**AMENDED 2-23-2015****CALIFORNIA TRAFFIC CONTROL DEVICES COMMITTEE (CTCDC) AGENDA****March 5, 2015 Meeting (9:00 am to 4:00pm)****Caltrans District 7****100 S. Main Steet****Los Angeles, CA 90012****Room 01.040A**

##### **14-05 Bicycle Signal Faces - CA MUTCD edits**

<b>Subject</b>	CTCDC Item 14-05: Bicycle Signal Faces	<b>Date</b>	2/2/2015
<b>To</b>	Chris Engelmann, Executive Secretary California Traffic Control Devices Committee (CTCDC)		
<b>Sponsor</b>	John Ciccarelli, Bicycle Solutions Member, CTCDC		
<b>Requesting Agency</b>	Caltrans

Figure xx-1 (CA)

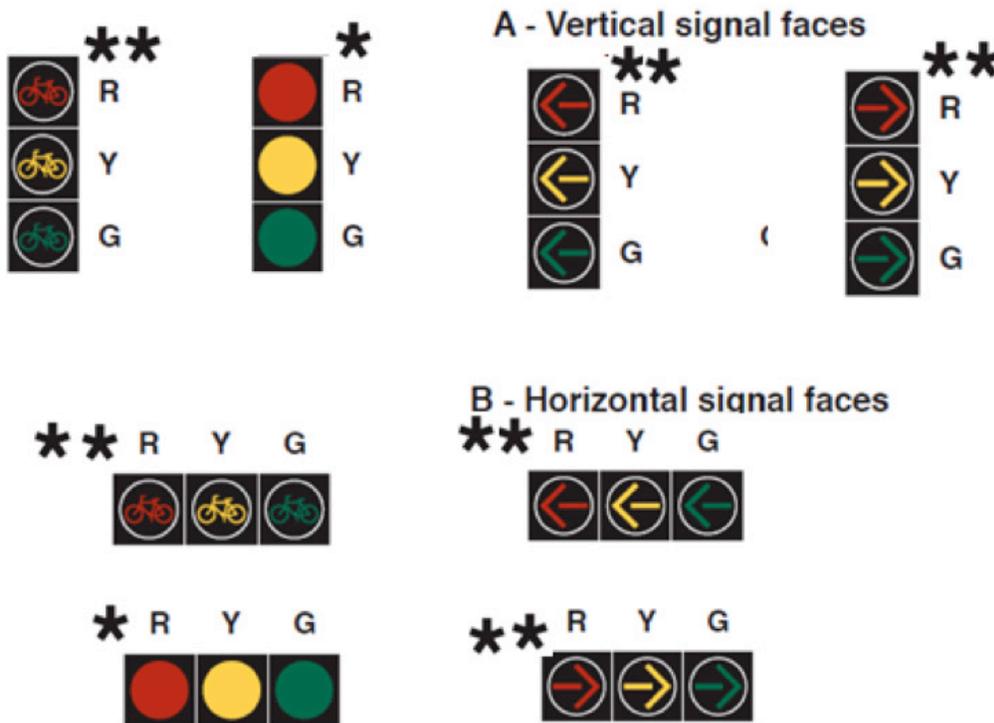
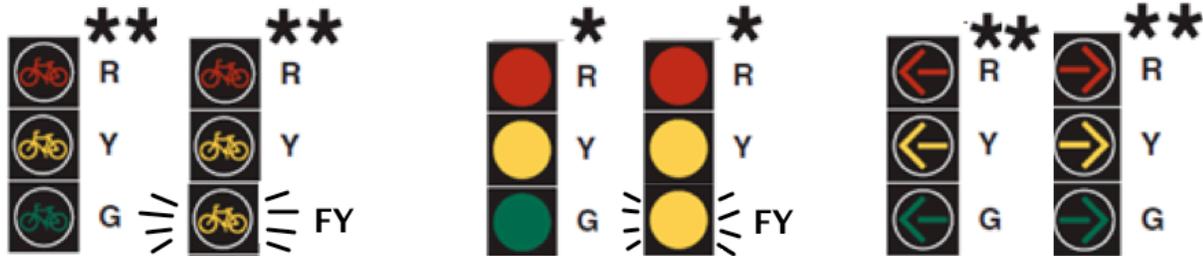
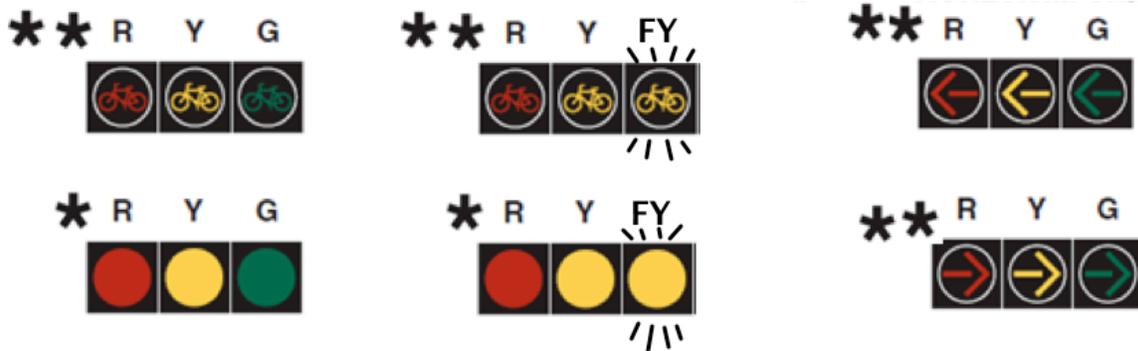
<BEGIN NCUTCD CONTENT DELETED FOR CALIFORNIA>

<BEGIN CALIFORNIA-SPECIFIC CONTENT (REPLACES NCUTCD's Figure xx-1) >

<i>Ramp Meter Activated Blank-Out Signs</i>	
Sign Code	Figure
W88-2 (CA)	
W88-3 (CA)	
W89 (CA)

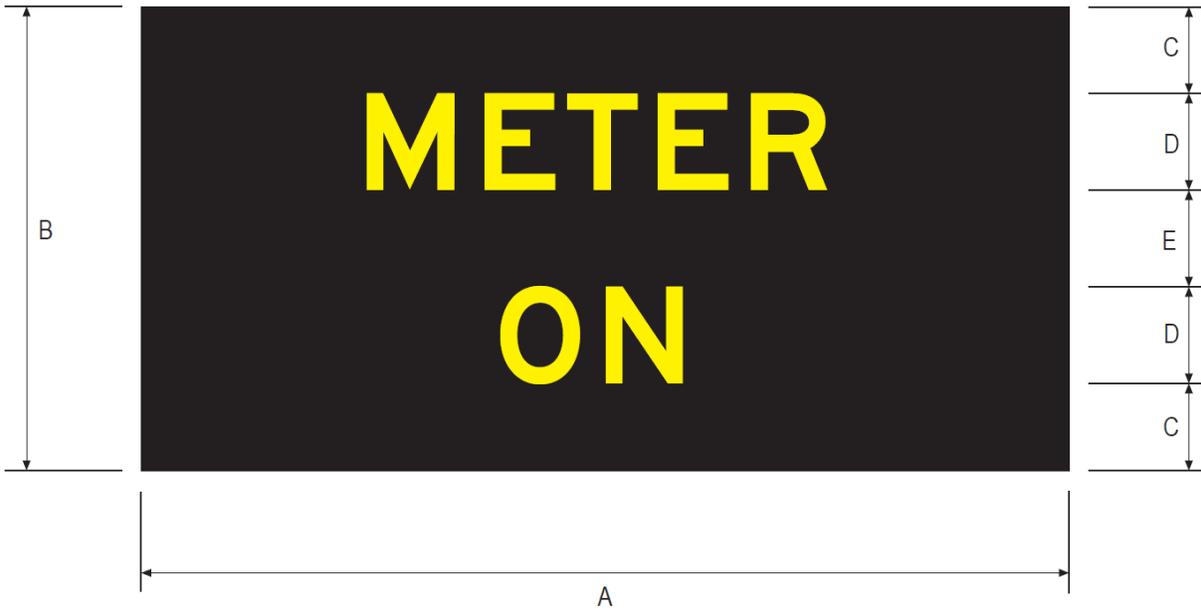
02 When the ramp control signals are ~~in operation~~ ~~operated only during certain periods of the day~~, a RAMP METERED WHEN FLASHING (W3-8) sign (see Section 2C.37) ~~or an internally illuminated overhead~~ **Activated Blank-Out "METER ON" (W88-2(CA), W88-3(CA) indication message sign, or an internally illuminated "METER ON" indication, or an extinguishable Activated Blank-Out "PREPARE TO STOP" (W89(CA)) message sign (see Figure 2C-6(CA))** should be installed in advance of the ramp control signal near the entrance to the ramp, or on the arterial on the approach to the ramp, to alert road users to the presence and operation of ramp meters.

CXXX (CA)

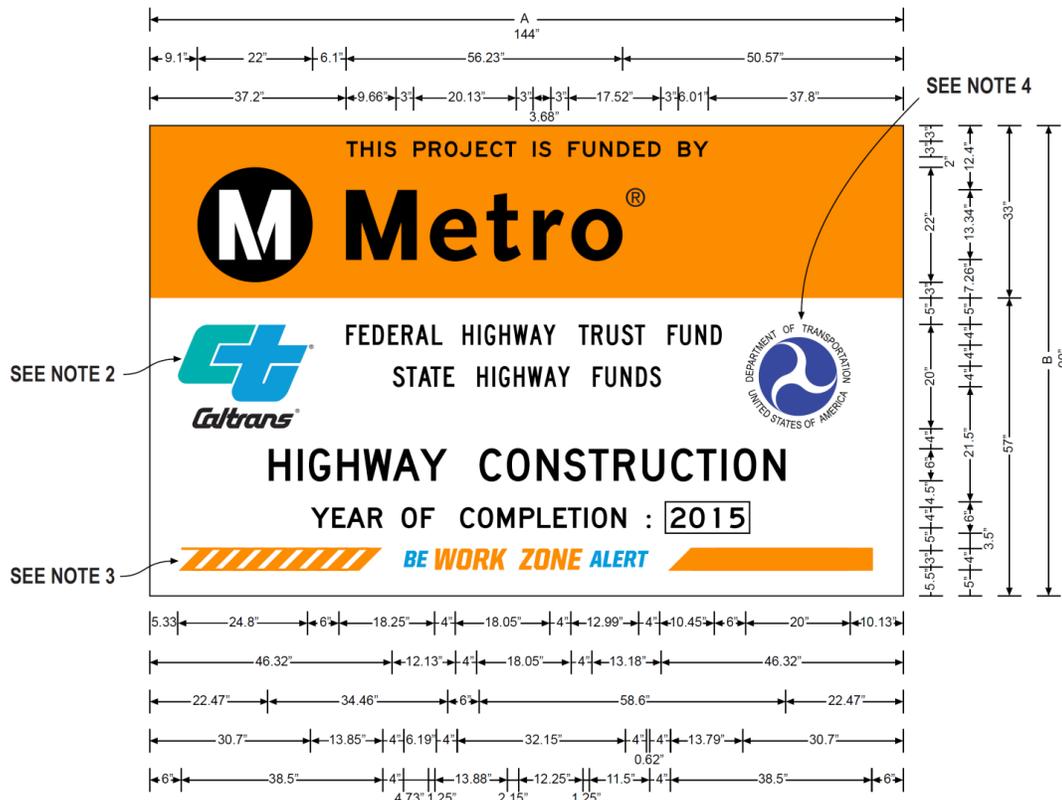
Proposed update for “Construction Funding Identification Sign” to be standardized in Part 6 of the *California Manual on Uniform Traffic Control Devices* (CA MUTCD). Freeway size: 144” W x 90” H; and, Conventional Highway size: 96” W x 60” H. The sign, shown below, was proposed for use on the I-405 project, with Los Angeles MTA (“Metro®”) as a major funding contributor to the project, and includes a new Caltrans “*BE WORK ZONE ALERT®*” safety campaign graphic across the bottom of the sign assembly.

Caltrans finds that the Municipal Planning Organizations (MPO’s) want to create sign with elements that do not meet CA MUTCD guidelines. This proposed design provides a uniform sign template for the purpose of presenting a temporary sign to identify participating funding entities, and funding sources. The orange-background funding header panel will provide options for local agencies to place their information, or Caltrans can offer variations that are similar to the 2006 “Revised Standard Plan T7.”

**Recommendation:** Caltrans is requesting approval to update the “Construction Funding Identification Sign” to be standardized in the California Manual on Uniform Traffic Control Devices (CA MUTCD)
